ATTN: CC2035 Testimony

We appreciate the opportunity to comment on the CC2035 Proposed Draft of zoning regulations for the Central City Plan District. BPS undertook an extraordinarily difficult task of overhauling the Comprehensive Plan and Zoning Code, and has done an amazing job of preparing a reasoned CC2035 Proposed Draft for review. While there are many proposed amendments to the zoning code that we fully support, we think important issues remain that need further consideration. Attached to this cover letter we offer a series of detailed amendments to the CC2035 Proposed Draft. Specifically we propose amendments as follows:

Amend Map 510-2 to provide a base FAR of 9:1 in the CX Zone in the West End Subdistrict

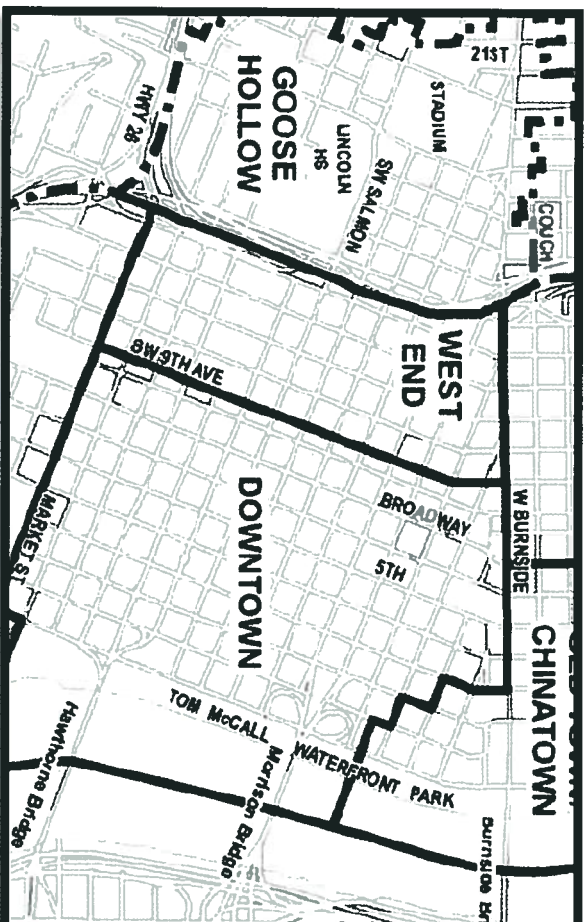
Today the portion of the West End between SW 9th and SW 11th is zoned CX, while the area west of SW 11th is RX. However, when the City adopted the West End Plan in 2002, it created an overlay for the area north of SW Salmon and west of SW 11th that generally permitted mixed-use development similar to the CX zone. The CC2035 Proposed Draft reinforces the mixed-use vision of the West End by rezoning much of the area north of SW Salmon and west of SW 11th as CX.

However, in setting the base FAR for the entire West End west of SW 11th at 8:1 (Map 510-2 in CC2035 Proposed Draft), the CC2035 Proposed Draft did not take into account the policy difference between the northern and southern portions of the West End. Staff explains its reason for the proposed downsized base FAR north of Taylor on page 48 of the CC2035 Proposed Draft as follows “*Staff proposes instead to set the base entitlement to 8:1 [north of Taylor], similar to the surrounding areas to the south.*” Given the policy vision for the CX portion of the West End, it would be more appropriate to set the base FAR for the “surrounding” CX zone between SW 11th and SW 14th at 9:1, consistent with its existing FAR and the FAR for the portion of the West End CX zone between SW 9th and SW 11th.

- Amending Map 510-2 to provide a base FAR in the CX zone of the West End west of SW 11th Avenue as 9:1.

Map 510-2 in Currently Effective Zoning Code

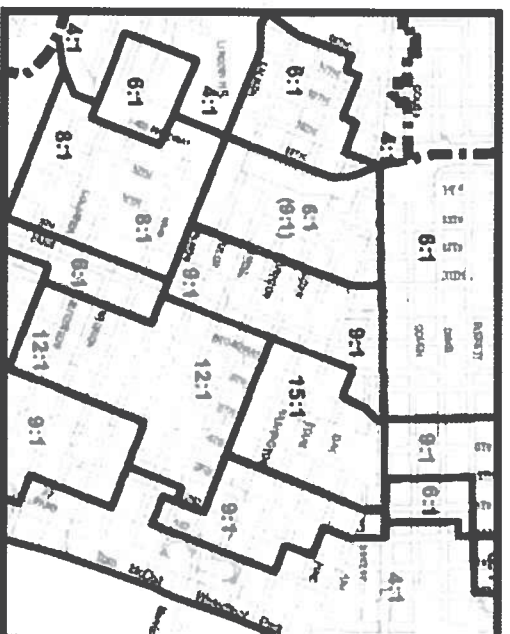
With regard to the base FAR, the existing zoning code acknowledges the policy difference between the northern and southern portion of the West End. The figure below is from Map 510-2 in the existing code. As shown, the area north of Salmon has a base FAR of 8:1, while the mixed use area between SW Salmon/W. Burnside and SW 11th/SW 14th Avenues has 6:1 FAR if less than one-third of a development is residential and 9:1 if more than one-third of the development is residential. The 9:1 FAR expressly mirrored the 9:1 FAR in the CX portion of the West End west of SW 9th,

Amend 33.510.263.B.1 to not prohibit parking and loading access on SW 1st Avenue between SW Stark and Washington where a lane of SW 1st Avenue is physically separated from the LRT alignment

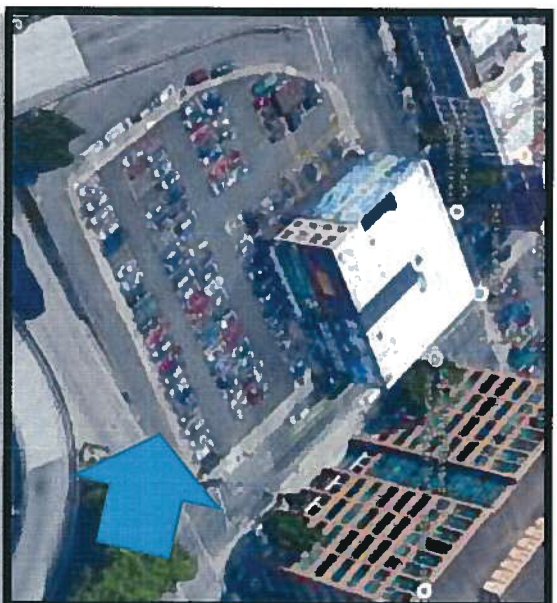
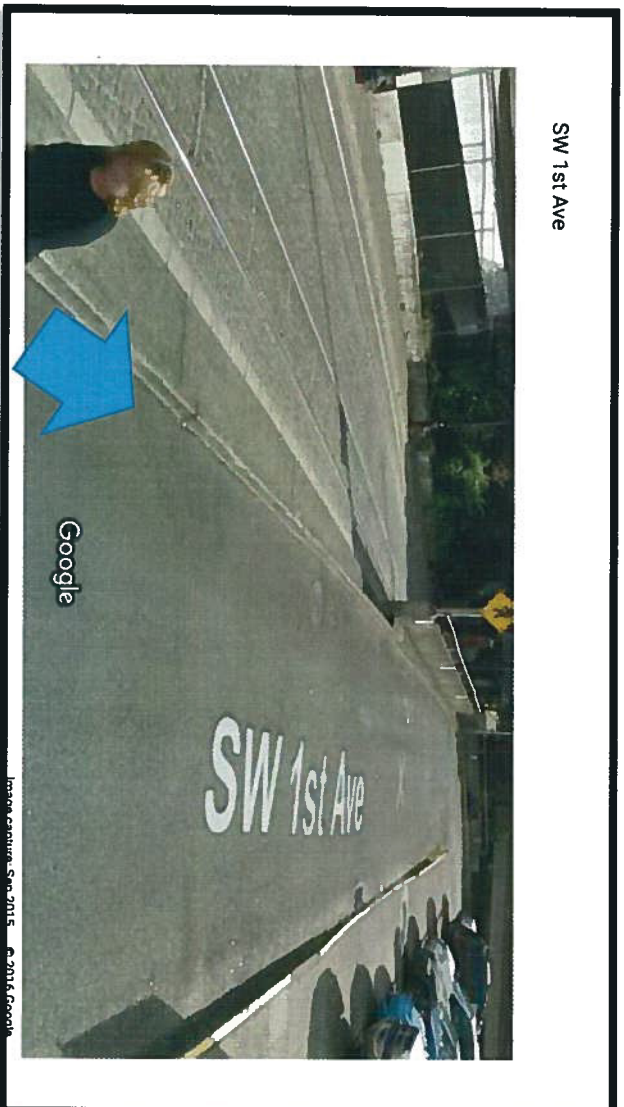
The Review Daft added PCC 33.510.263.B.1.f, which prohibits motor vehicle access to parking and loading along SW First Avenue between NW Davis Street and SW Morrison, the segment where light rail operates on SW First Avenue. However, a unique situation exists at SW 1st Avenue between SW Stark and SW Washington, which is not properly accounted for in the code language.

As shown below, the auto circulation lane on SW 1st Avenue at this location is physically segregated from the light rail alignment due to the grade change as the light rail alignment dips below the Morrison Bridge ramps adjacent to SW Washington.

Because it is physically separated, allowing parking and loading access on SW 1st Avenue between SW Stark and Washington would not impair light rail operations. Moreover, parking and loading access on SW 1st Avenue in this location may be preferable than using SW 2nd or SW Stark, which are Major City Bikeways. The physical alignment of SW Washington in this location may not be ideal for parking and loading access, and can only be accessed by SW 1st Avenue anyway. So overall, prohibiting parking and loading access on SW 1st Avenue between SW Stark and Washington does not facilitate light rail operations in any way, and may lead to using alternative access ways that are less desirable based on City objectives.

*f. On 1st Ave between NW Davis Street and SW Morrison Street, **except between SW Stark and SW Washington.***

Maximum heights on several downtown sites were unduly lowered to allow views from Upper Hall Street (CC SW24); a viewpoint that is not used and cannot be safely used by pedestrians, bicyclists, or motorists

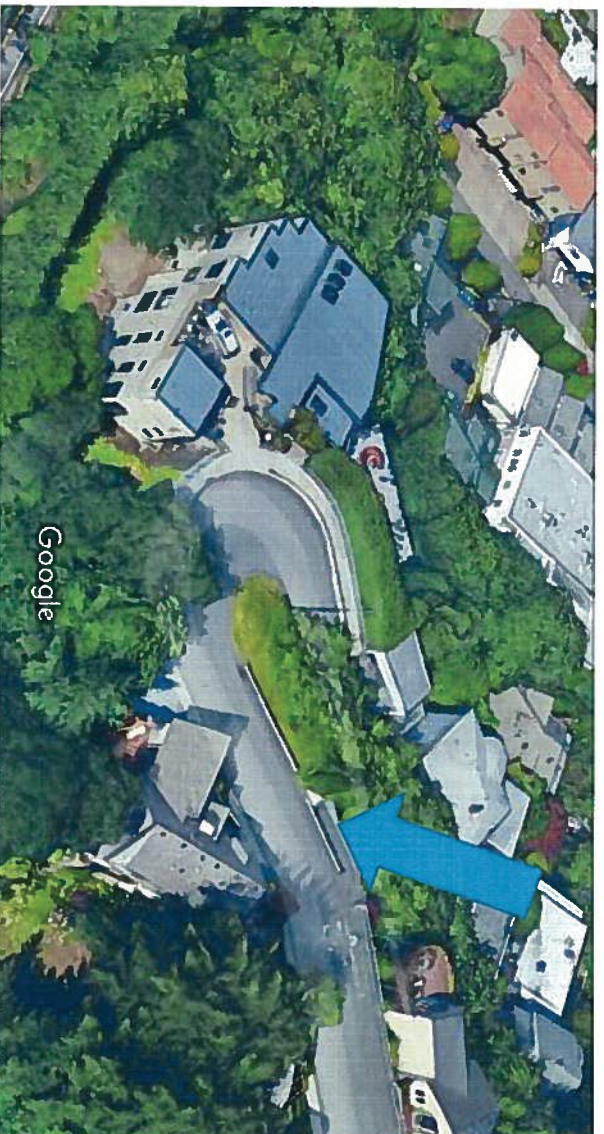
As you can see below, the viewpoint sits at the end of a sidewalk that does not provide continuous pedestrian access that sits at the beginning of a hairpin curve. There is no viewpoint, as shown by the arrow it is simply the stub-end of an incomplete sidewalk where vegetation blocks views.

The hairpin turn is, for the most part, a blind turn for motorists. Extreme care is required in both directions to avoid cars coming from the other direction, as one makes the hairpin turn. Parking in this vicinity should be disallowed, for it makes the hairpin turn even more difficult and unsafe. The sidewalks on neither side of Upper Hall are used by pedestrians very often; and the continuous sidewalk on the west side of Upper Hall is the sidewalk does is used, to the limited extent either sidewalk is used.

As a result of its location, the City evaluation gave it gets a zero rating for developed as a viewpoint, access to viewpoint, and use as a viewpoint.

As a result, of its lack of access, unsafe location, lack of use, and economic impacts, we suggest that the Upper Hall Street viewpoint no longer be a protected viewpoint and as a result that the Map 510-4 be amended to include Bonus Heights that do no reflect the viewpoint, as originally proposed in the Discussion Draft, and shown below.

Scenic Resources Protection Plan
Map 480-2 (Map 9 of 12)

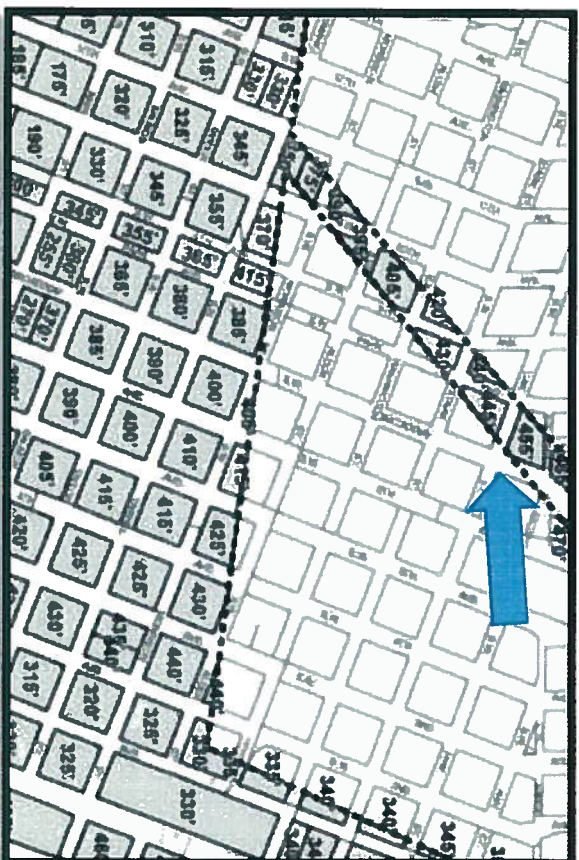
The City's evaluation regarding the economics of protecting this viewpoint is also incorrect. The evaluation in the Scenic Resource Protection Plan concludes "*Due to the elevation of the viewpoint, there is minimal economic impact from protecting the views of Mt Adams and Mt St Helens.*" (Central City Scenic Resources Protection Plan: Proposed Draft, Summary, Results and Implementation; June 20,

2016, page 91). As shown in the “480 Maps” prepared by the City, protection of this viewpoint results in a swath of reduced development capacity through the West End and Downtown subdistricts.
